NUCLEAR REGULATORY COMMISSION  
REGION I  
475 ALLENDALE RD.  
KING OF PRUSSIA, PA 19406-1415

RESPONSE TO CONTROL #129009

RE: License Renewal  
Control #129009

LABORATORY FACILITIES/FLOOR PLAN

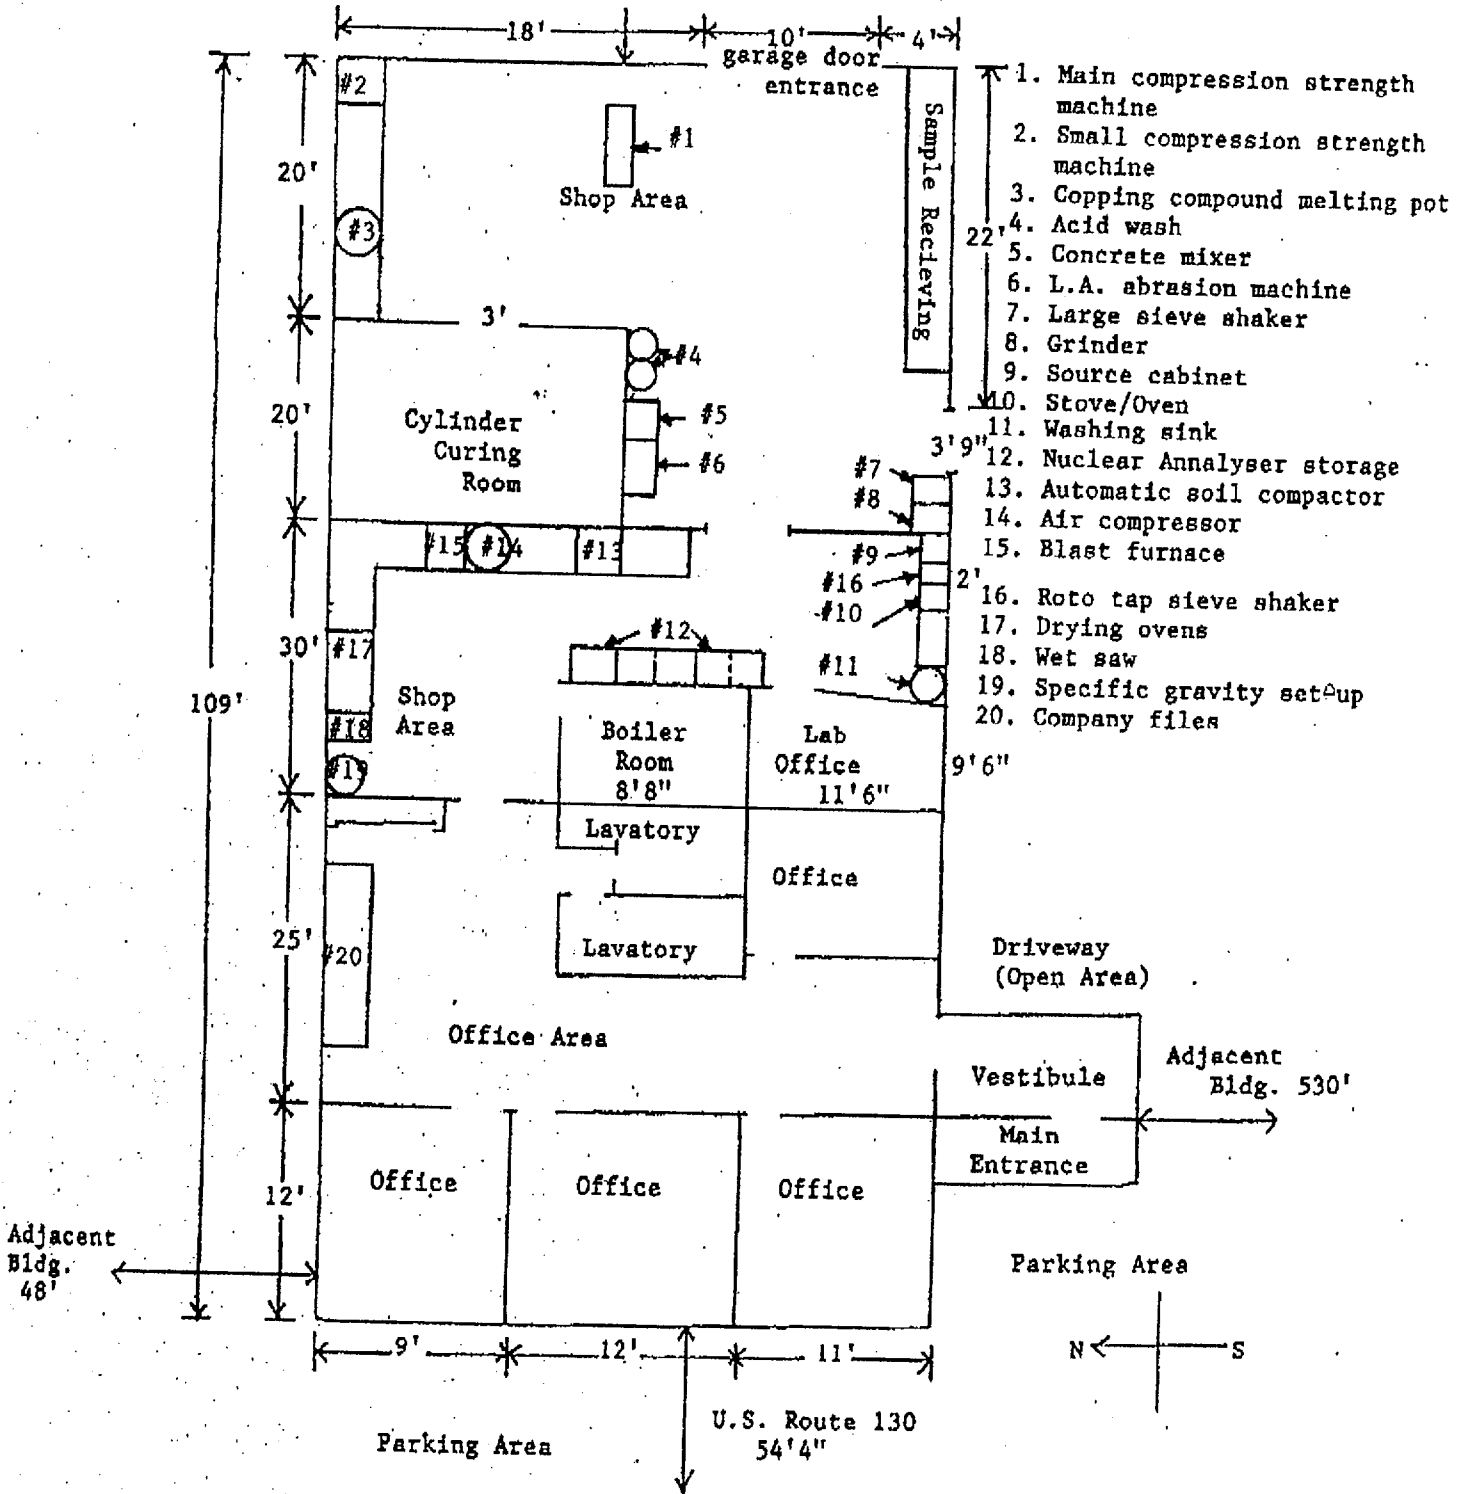
1. At this time, Certified Testing will not perform calibrations of Survey Instruments. All calibrations will be performed by NRC License Companies.
2. Storage of Sources at our Bordentown office are located in the back office in a locked storage cabinet. Dimensions are 5' x 10' H x 31"D x 2'7" W. The door is sheeted with 1/16" lead sheets. The back of storage is a concrete block wall. See attached diagram.
